NORTH VALLEY WATER DISTRICT

RE: Information requested from North Valley Water District
regarding public hearing on Enbridge Petroleum- Case No. PU-07-75
and PU-07-108

4 ENBRIDGE GAS PIPELINE CROSSING DETAIL
 5 SCALE: NONE

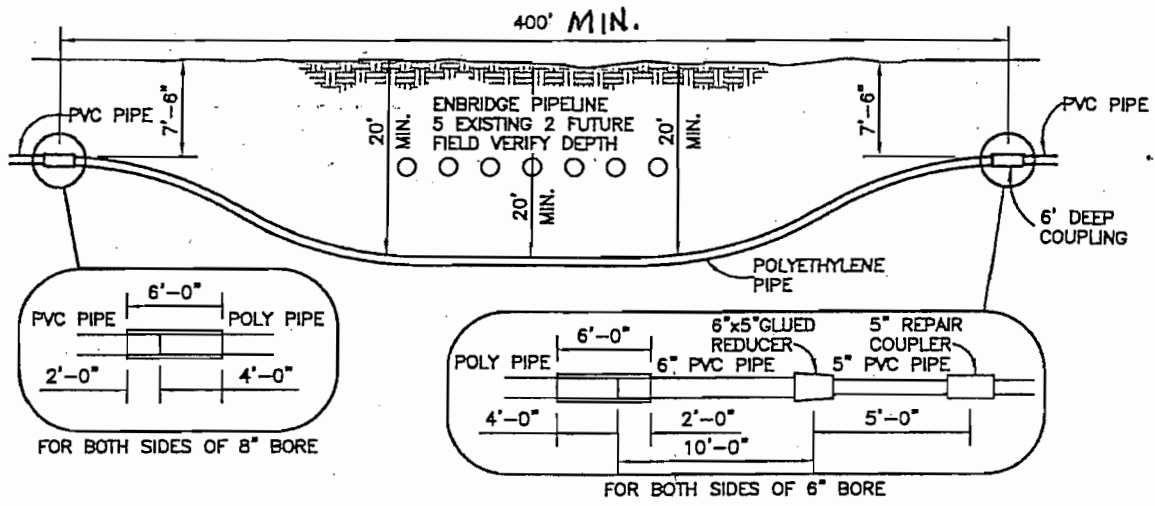
To minimize any disruption to water service or any exposure to public health risks from contamination, I suggest that Enbridge be responsible for the cost of directional boring and installation of heat-fused polyethylene pipe under Enbridge's pipeline corridor at a minimum of 20-foot depth below natural ground, or a 10-foot minimum separation under Enbridge's deepest pipeline.

At the hearing, I suggested a horizontal distance of 500 feet to allow for any future Enbridge pipelines.

I am enclosing a detail drawing for one of the locations where NVWD has planned some pipeline work with two pipelines in parallel that would be bored under Enbridge's pipeline corridor.

This would be a typical profile of the type of installation that I suggested in my testimony. This detail is my submittal for the information you requested.
